# Initial Project Review

## Shoreline Substantial Development Permit / Shoreline Conditional Use Permit / Shoreline Variance: Hannula and Beckman

**Application Numbers: 895673, 895674, 895675, 897245**

## Site Plan

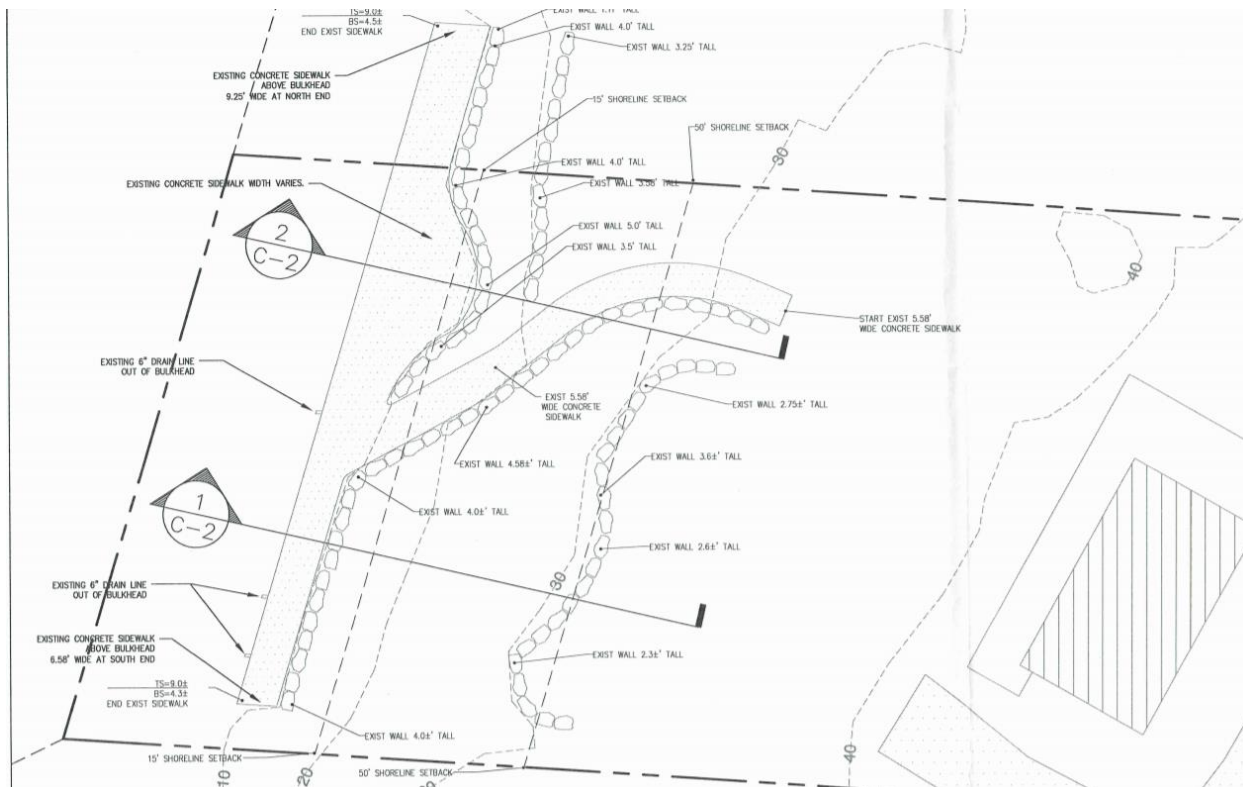
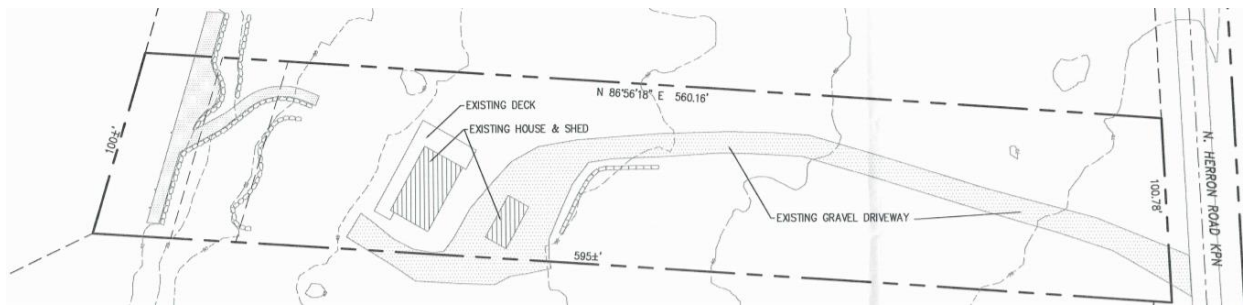
*The retaining walls and pathway will alter the existing physical character of the shoreline; therefore, prior to approval, the applicants must submit a Geotechnical Assessment for review to justify the need for the bulkhead and upland walls. If the project is approved, staff will request conditions to plant native shoreline vegetation landward of the bulkhead and between the walls in order to provide additional aesthetic value to the developed area near the shoreline as well as screening of the walls.*

*The submitted site plan does not indicate the total impervious coverage of the sites and whether or not it exceeds the maximum impervious coverage of 33.3% as allowed by PCC (within 200 feet of shoreline jurisdiction). Therefore, staff will recommend a condition of approval for the applicants to demonstrate this calculation to be equal or less than the maximum 33.3%, as allowed by Pierce County Code, on each parcel.*
